SUBJECT: ISSUANCE OF AMENDMENT NO. 64 TO FACILITY OPERATING LICENSE
NO. NPF-14 - SUSQUEHANNA STEAM ELECTRIC STATION, UNIT NO. 1

AMENDMENT TO FACILITY OPERATING LICENSE

Amendment No. 64
License No. NPF-14

SAFETY EVALUATION BY THE OFFICE OF NUCLEAR REACTOR REGULATION

MAXIMUM AVERAGE PLANAR LINEAR HEAT
GENERATION RATE (MAPLHGR) VERSUS
AVERAGE PLANAR EXPOSURE
GE FUEL TYPES 8CR233 (2.33% ENRICHED)
FIGURE 3.2.1-1

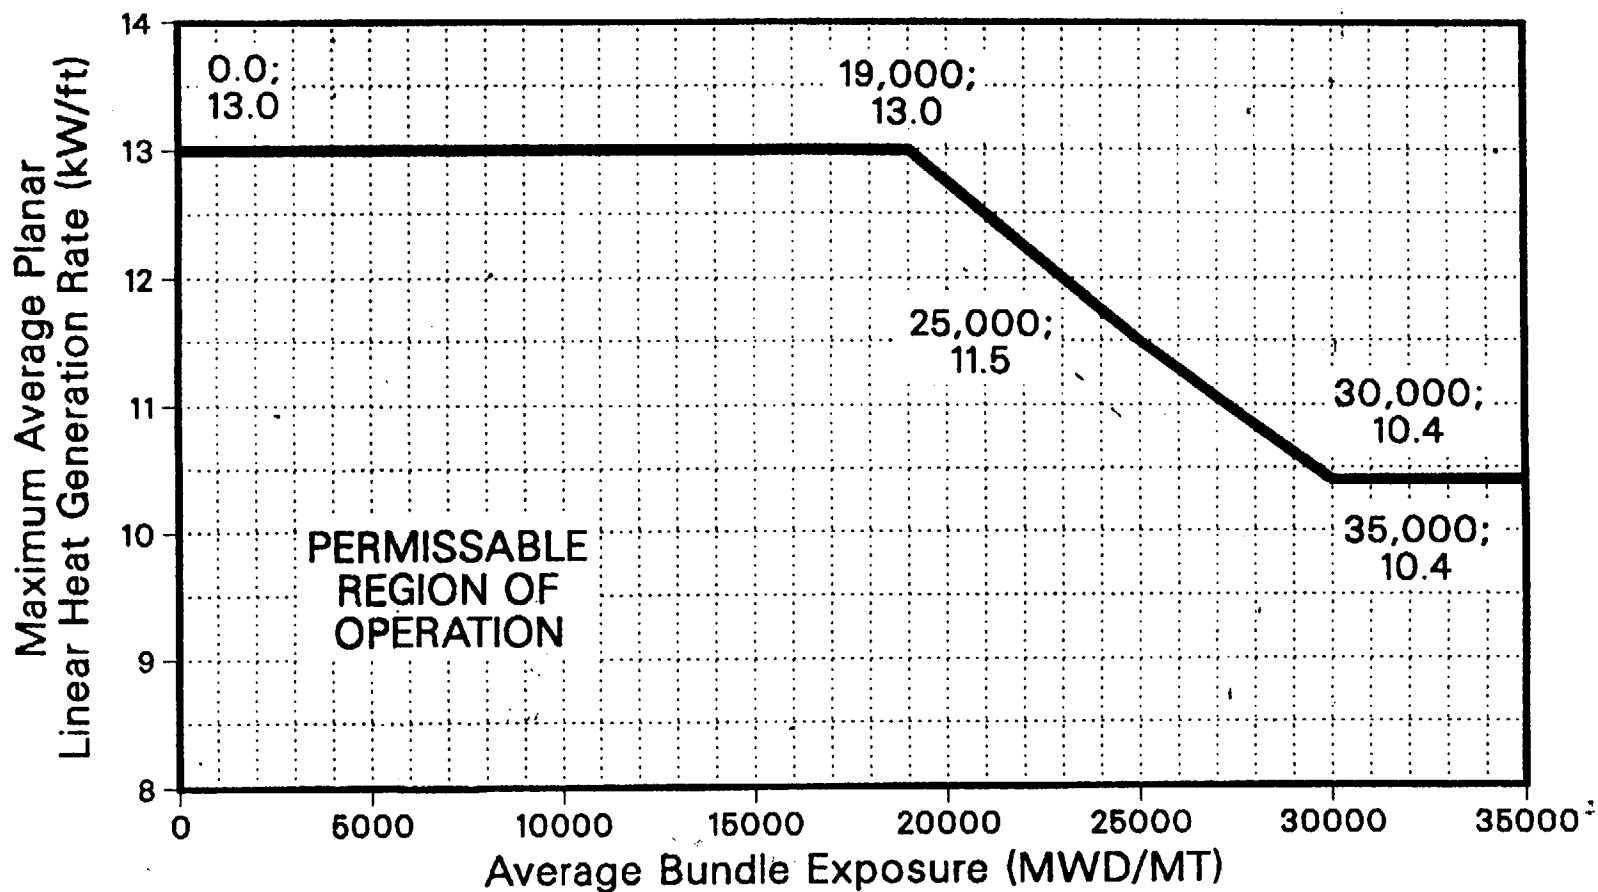
- (1) MAPLHGR limits for the resident GE fuel bundle types 8CR233 are extended from an average planar exposure limit of 33,069 MWD/MT to 40,675 MWD/MT. The resulting peak cladding temperature (PCT) limit and local oxidation fraction were calculated by GE based on the same plant conditions and systems analysis used to derive the current MAPLHGR limits defined in the SSES FSAR. The calculated values are well within the 10 CFR 50.46 Appendix K limits.

- (1) Figures 3.2.1-1 and 3.2.1-2: These revised Figures replace the previous Figures and reflect the results of additional GE and ENC LOCA analyses.
- (2) Figures 3.2.3-1 and 3.2.3-2; Table 3.2.3-1: These Figures define core flow dependent MCPR operating limits and power dependent MCPR operating limits which consider the results of revised ENC analyses using recently approved methodology and the prior SIC3 analysis of the Rod Withdrawal Error transient. The licensee has proposed the deletion of Table 3.2.3-1 which summarized the MCPR results applicable to the SIC3 reload analysis. Since some of the conditions defined in this Table are no longer applicable (e.g., a Rod Block Monitor Trip Point setting of 106%), the staff finds the deletion acceptable. It is noted that this approach is consistent with that used and approved for Susquehanna, Unit 2 in Amendment 31 to License No. NPF-22 (October 1986).

**FLOW DEPENDENT MCPR OPERATING LIMIT
FIGURE 3.2.3-1**

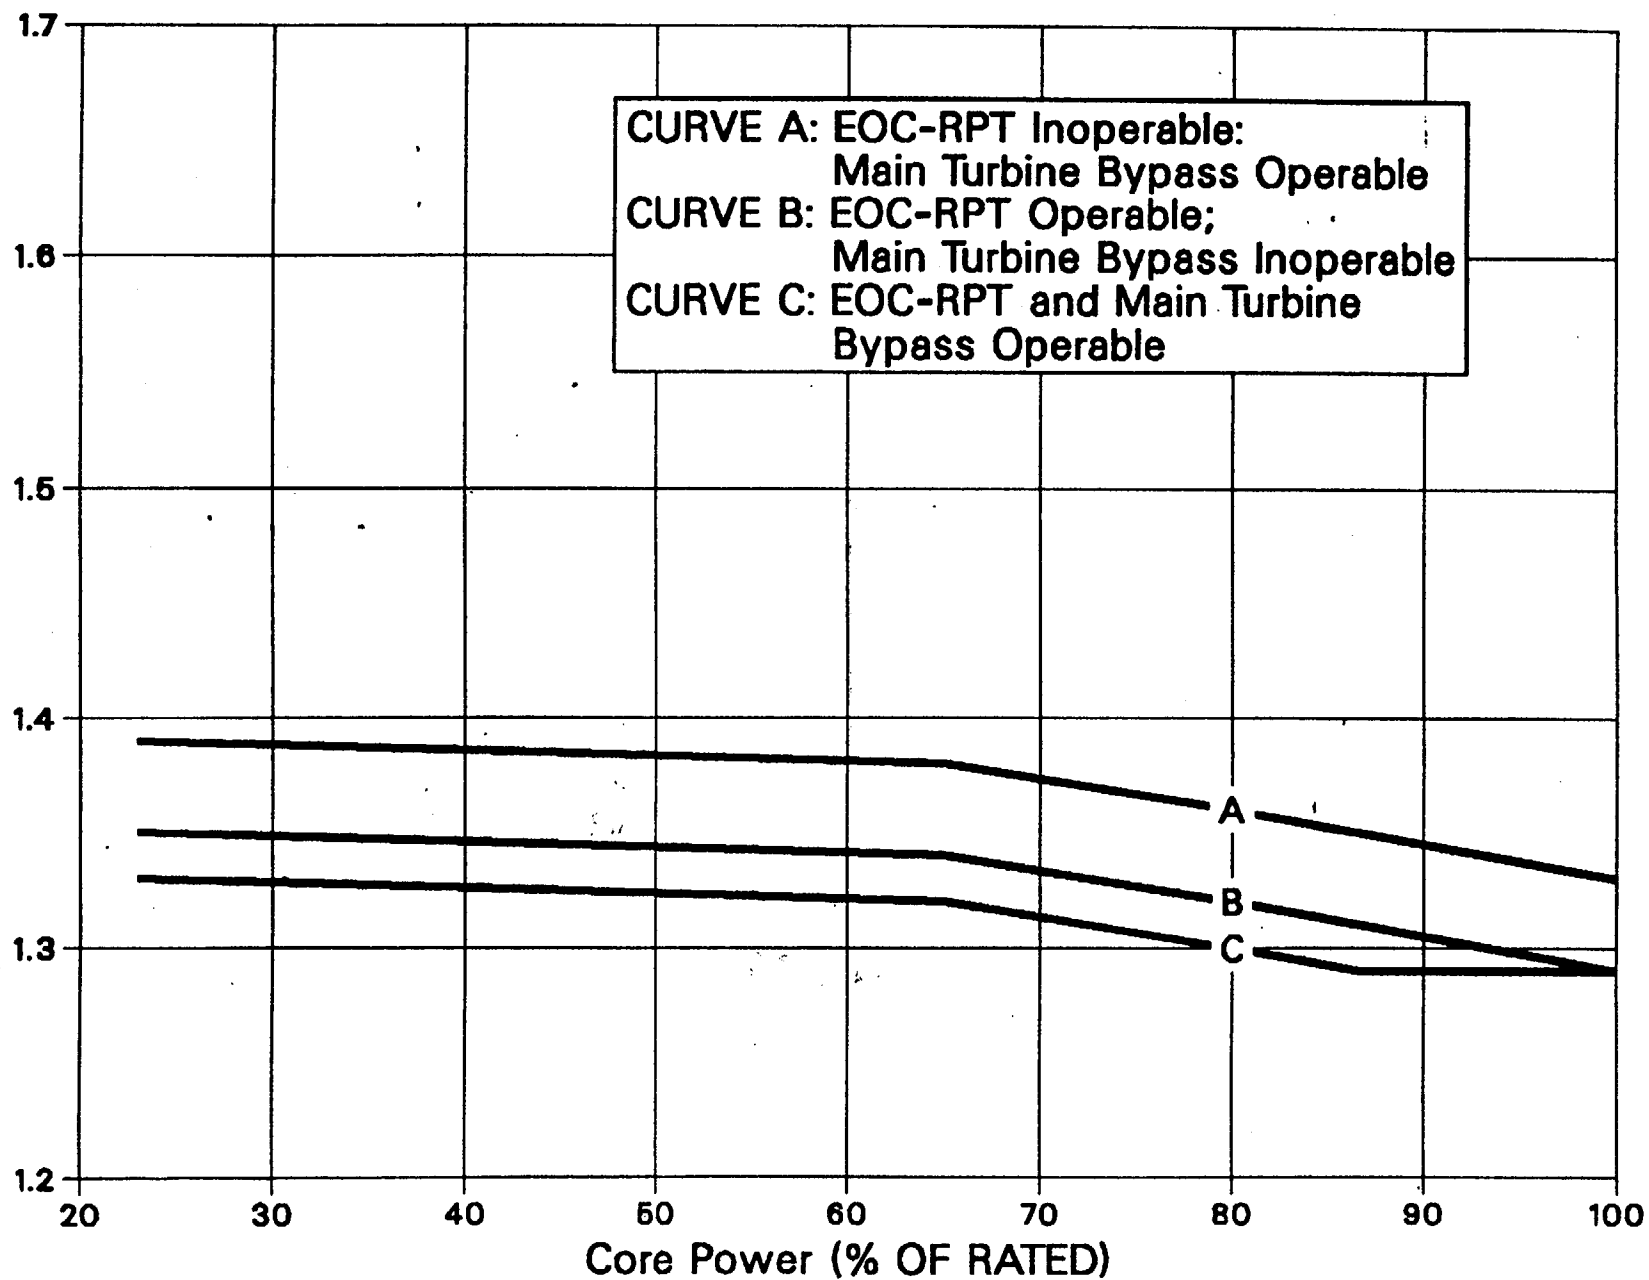
- (3) The Minimum Critical Power Ratio (MCPR) operating limits have been reevaluated by the licensee to reflect the results of transient thermal-hydraulic core analyses with the XCOBRA-T computer code. The staff has found the use of this code acceptable for BWR licensing calculations (Letter, G. Lainas, NRC to G. N. Ward, ENC dated October 27, 1986 "Acceptance for Referencing of Licensing Topical Report XN-NF-84-105, XCOBRA-T: A Computer Code for BWR Transient Thermal-Hydraulic Core Analysis").

The licensee has taken into account the impact of reduced flow and reduced power on transient response. This is reflected in the new flow dependent and power dependent MCPR operating limits incorporated in the SSES Unit 1 Technical Specifications. The automatic flow control mode of operation is still not permitted for SSES Unit 1.

Figure 3.4.1.1.1-1
THERMAL POWER LIMITATIONS

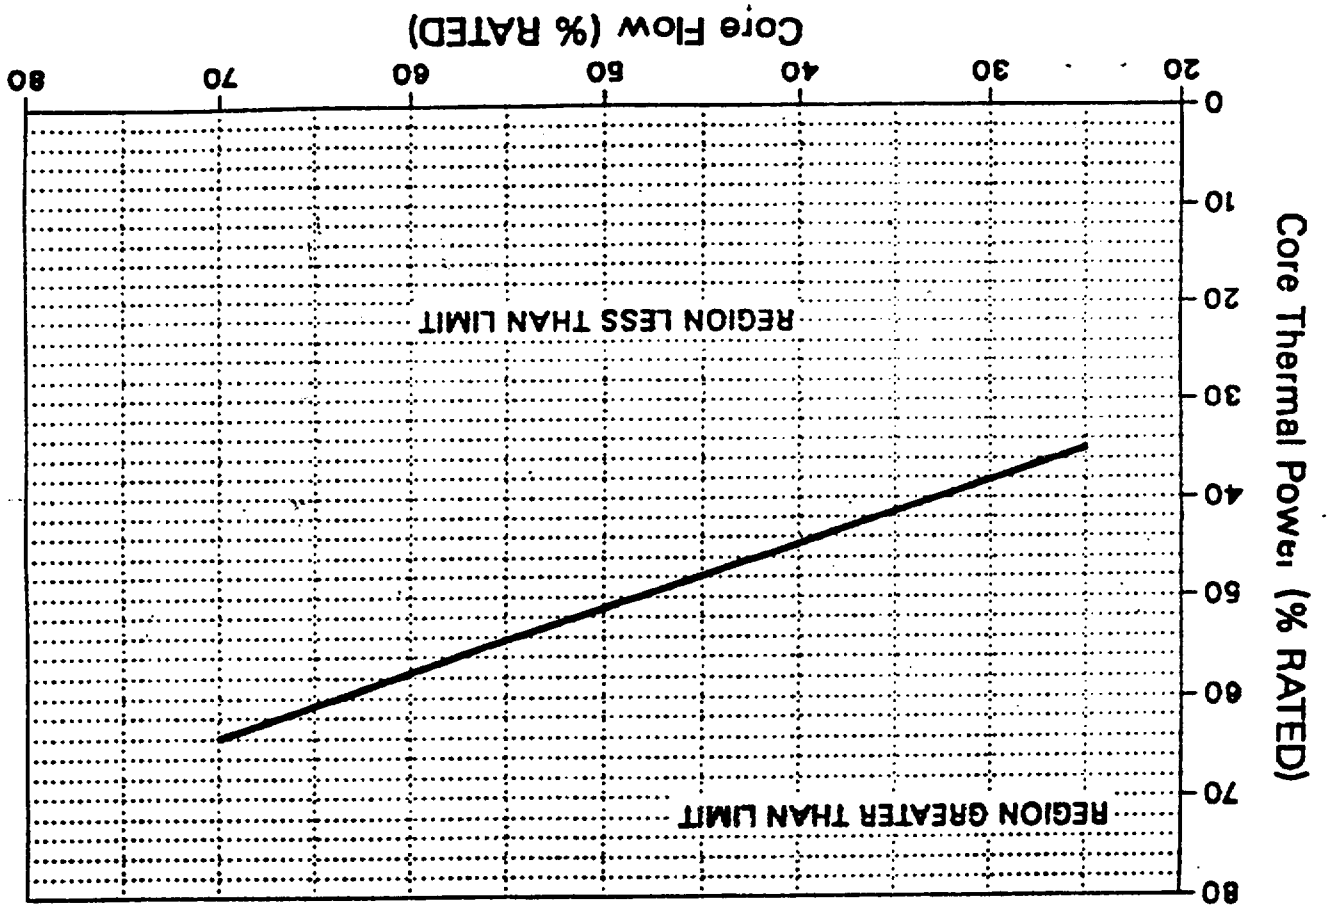
- (4) The licensee has proposed a modification to the present Technical Specification Limiting Condition for Operation (LCO) for the Single Loop Operation (SLO) mode. The proposed change consists of setting the MAPLHGR limit multiplier to 0.0 for extended SLO. The effect of this change is to preclude SLO for an extended period of time. This is an interim measure until ENC can provide revised analyses to justify applicability of the General Electric operating limits as specified in General Electric Service Information Letter 380 Revision 1 to Exxon fuel loadings. Revised analyses with current approved methodology are to be provided in a future submittal and should include a specific analysis of the one-pump seizure accident. The approach and changes to the Limiting Conditions for Operation are the same as those previously reviewed and approved by the staff in connection with our review of SSES Unit 2 reload submittal (Amendment No. 31 to Facility Operating License No. NPF-22, dated October 3, 1986) and are acceptable.

- (3) LCO 3.4.1.1.2 and Table 3.3.6-2: Changes were made to restrict operation in the single loop mode until additional analyses can be provided to justify applicability of the GE operating limits to Exxon fuel loadings.
